Subject: Agreement Regarding Tree Planting and Building Setback at Bethel Middle School

SHEET TITLE: SITE LAYOUT

PROJECT TITLE: BRYANT SD SOLAR ARRAY
SCENIC HILL SOLAR
BRYANT, ARKANSAS

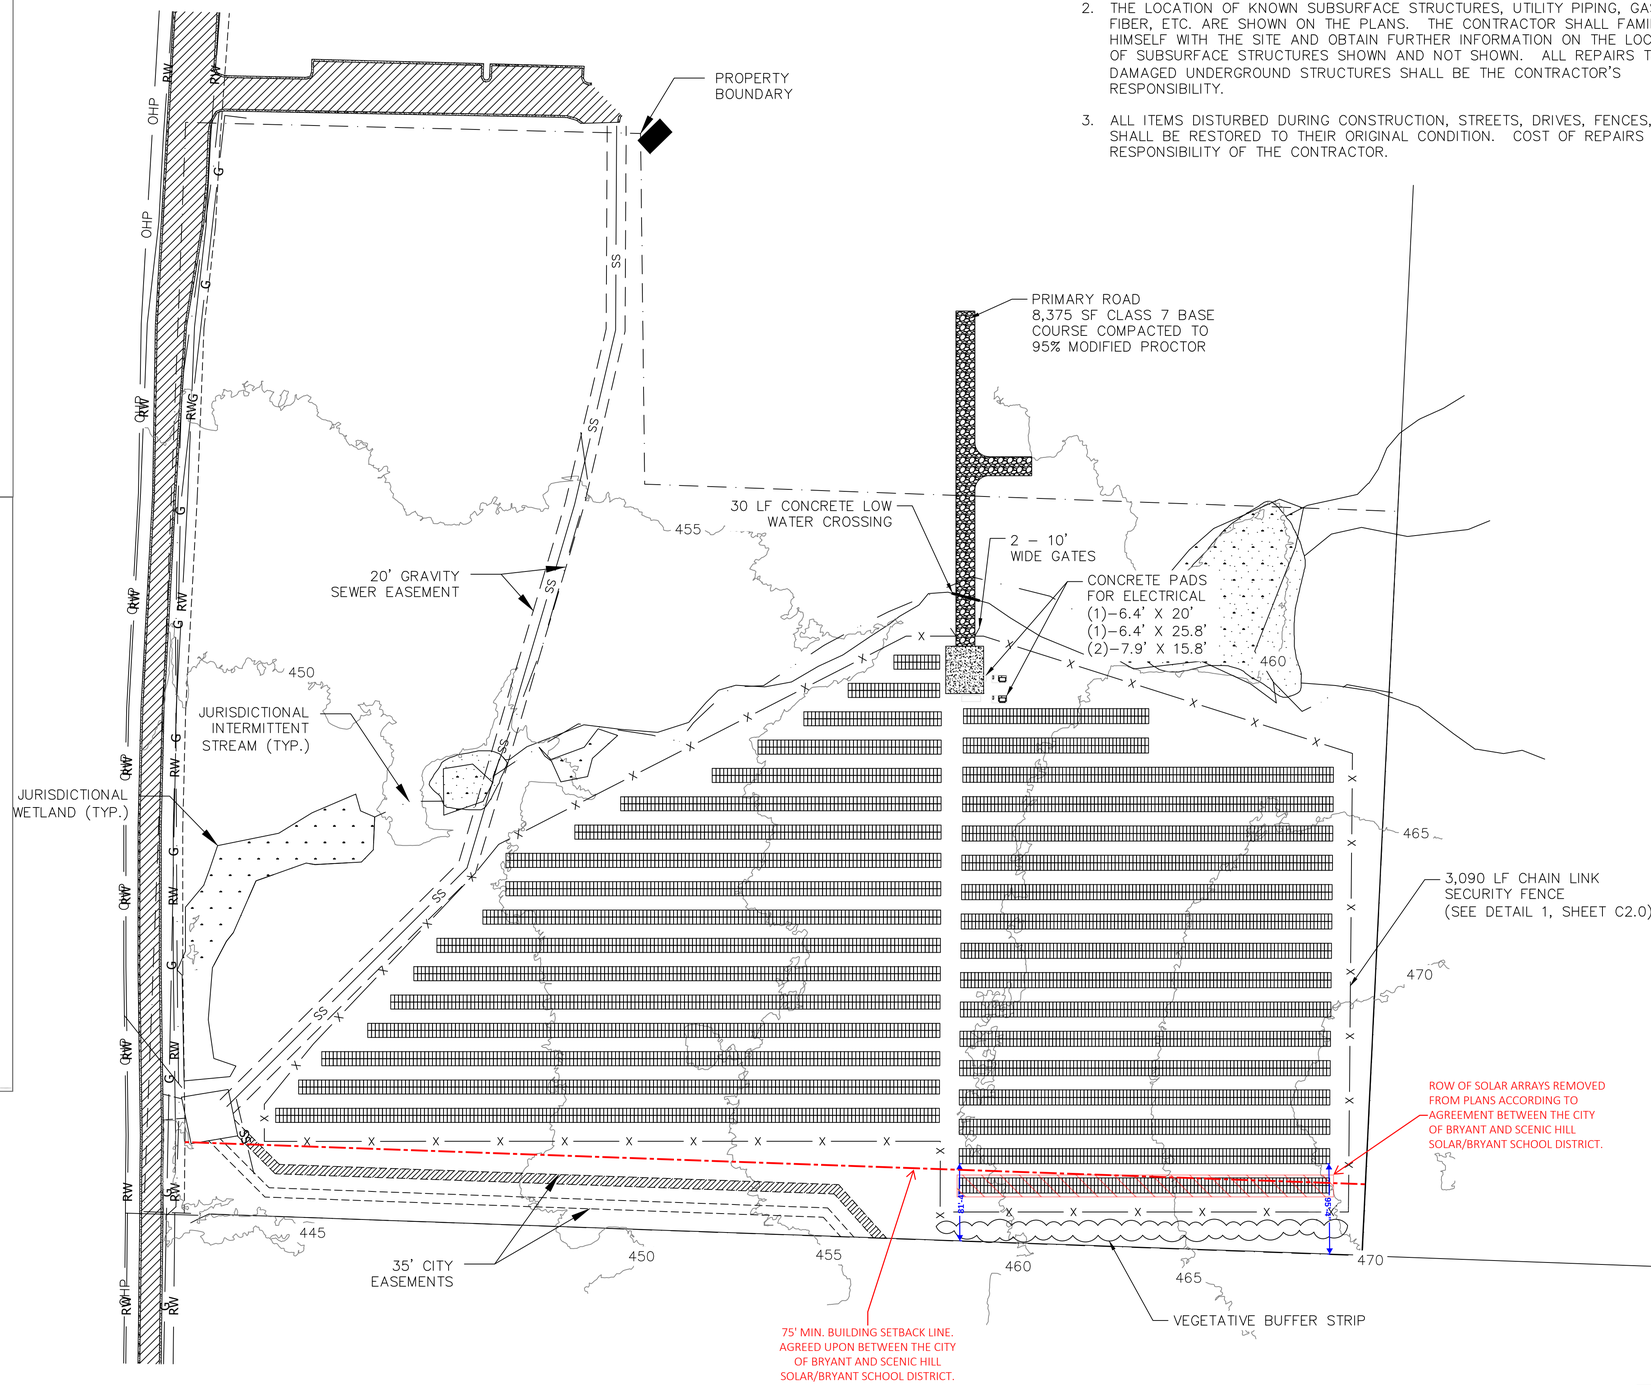
As per our discussion, **Scenic Hill Solar** will undertake the planting of Bradford Pear trees, or other agreed upon Evergreen Trees, along the southern property boundary between the **Bethel Middle School** property and the **Saratoga Place Subdivision**. This specific section of the boundary extends approximately 500 feet.

Furthermore, **Scenic Hill Solar** and the **Bryant School District** have mutually agreed to modify the solar array design. This modification involves the removal of one row of solar modules from the southernmost portion of the array, thereby establishing a minimum building setback of 75 feet along the southern boundary line of the Bryant School District Property.
